Decoupling TSN YANG modules from .1Q bridge

P802.1Qcw/D1.2 comment resolution

Comments #13, #14, #15, #16 against P802.1Qcw/D1.2:

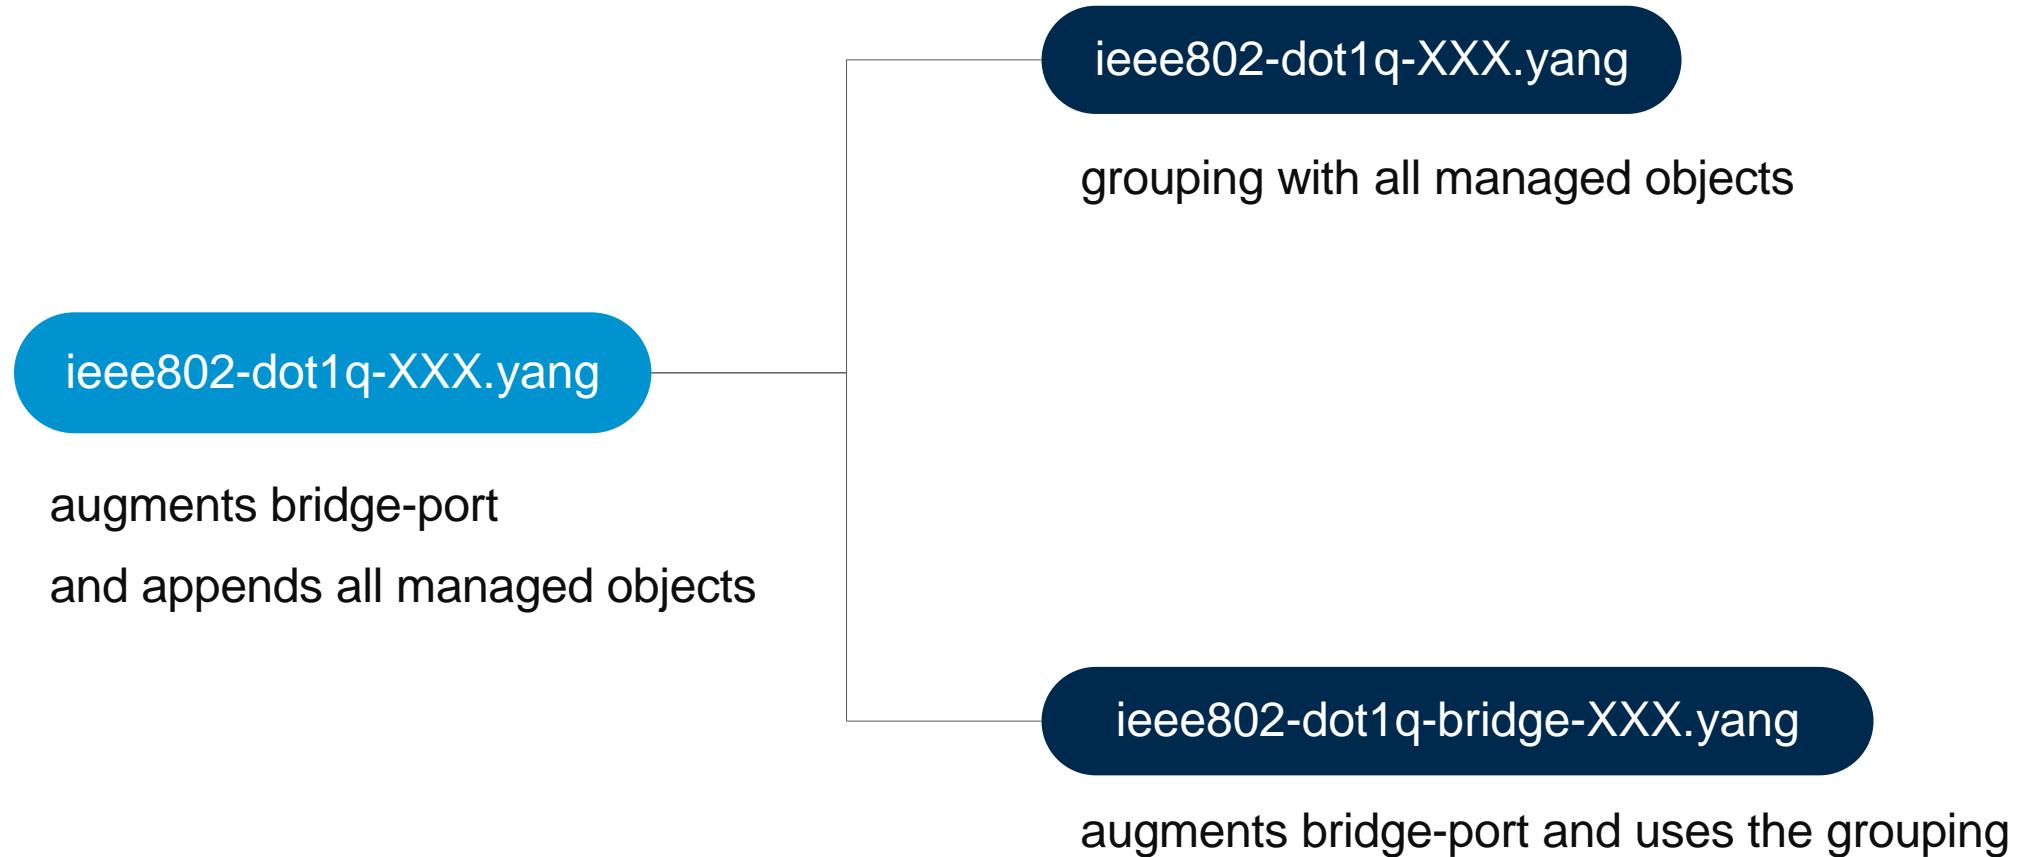
→ “*Tie QoS variables to Interfaces, not bridge-port.*”

Proposal from YANGsters (Scott Mansfield)

→ Copy Qcx!

Proposed YANG Hierarchy: Option 1

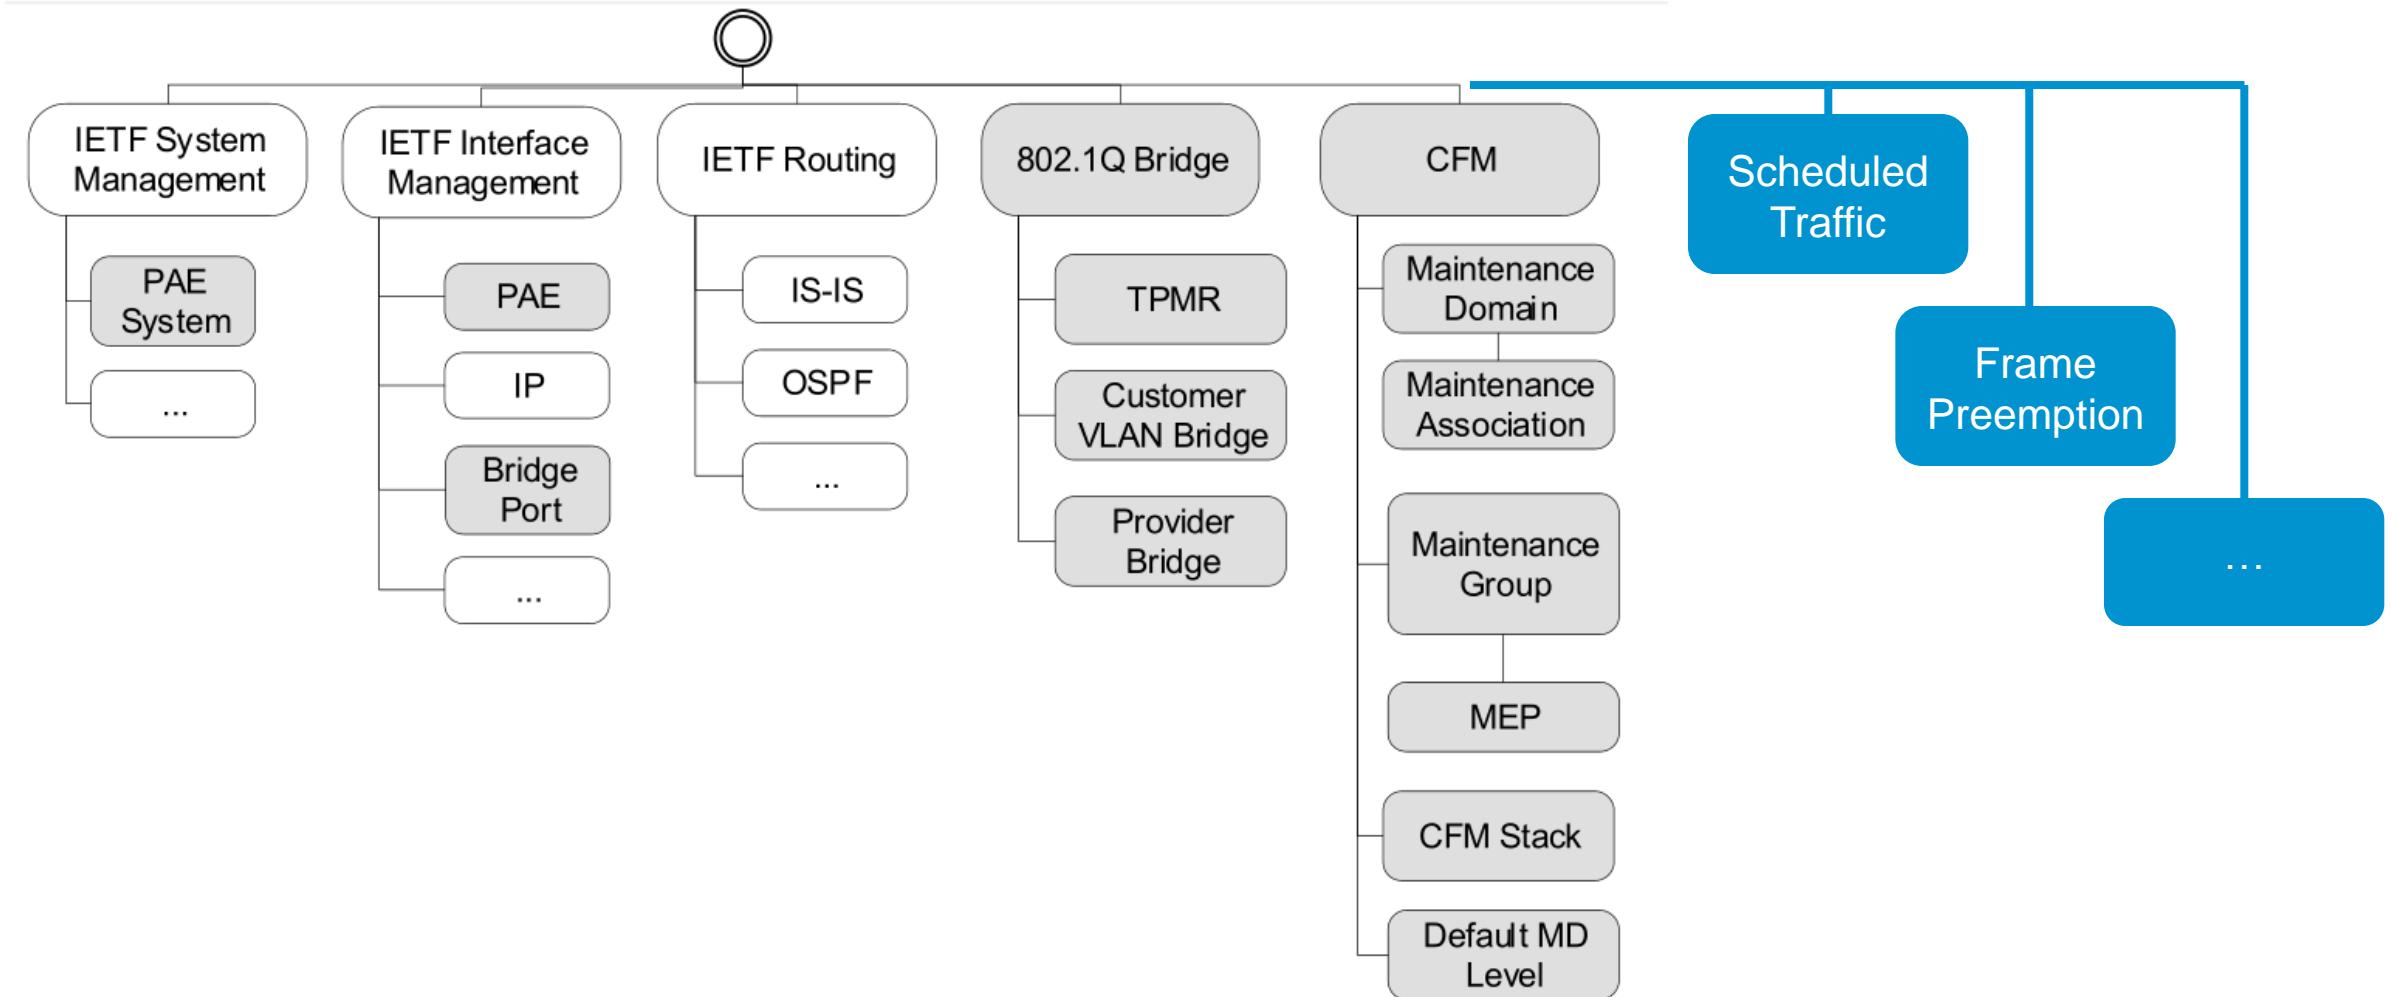
- Should we create a TSN branch? or have completely independent modules?
